VEAX LLO Existing Cable Piers Locations

NOTE: This drawing is NOT correct yet. It was made by mirroring the VEAY drawing D1201231-v1. Its ultimate purpose is to show the existing cable tray and piers relative to the as-built IFO.

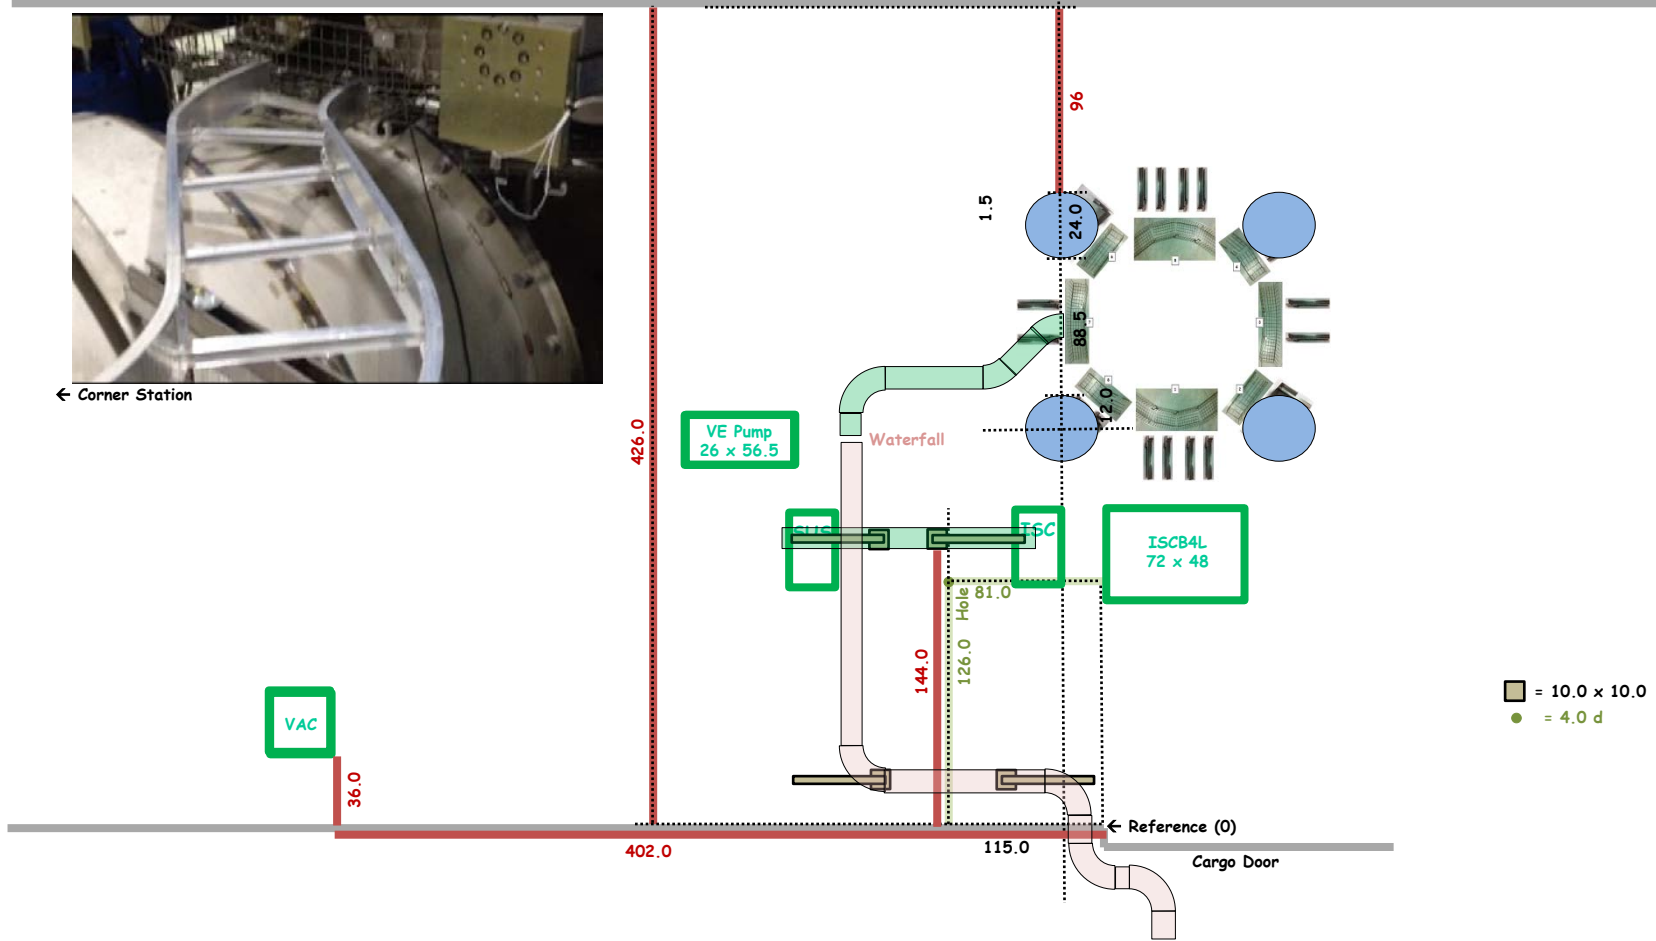
Questions and comments:

- 1) Where does 11U Short Rack (D1001423-v11) go? (Ignore)
- 2) Where does L1-AOS-XR1 (if it needs to exist) go? (Does not exist)
- 3) What does pentagon-2 mean regarding tray removal? Is there tray across the beam tube from L1-SUS-XR1? (Ignore)
- 4) Is the called-out 10' height important for some reason? LLO height is 8'. (OK)
- 5) What are the double doors in the note all about? (Ignore)
- 6) A door is missing from the garb room to the VEA. (Ignore)
- 7) The doors are missing from the mechanical room. (Ignore)
- 8) L1-VAC-XR1 is missing. (Shown)
- 9) All cabling that currently uses under-beam tray and the waterfall is missing. (Kurt)
- 10) The Photon Calibrator is missing. (Mounted to tube - part of OPLEV)
- 11) VE Pumps are not shown. (Shown)
- 12) Size of ISCB4L is not specified. (72 x 48)

Things that can be done: (Note: Blue trace is (mostly) existing tray.)

- 1) Remove old cable tray and pier that interferes with dome parking.
- 2) Locate L1-ISC-XR1 farther away from existing pier for clearance.
- 3) Suggest joining basket around BSC to existing cable tray at waterfall.
- 4) Used removed pier to extend cable tray to L1-ISC-XR1.
- 5) Add cable tray to reach L1-SUS-YR1.
- 6) Remove parallel waterfall, move 'T' to primary waterfall.
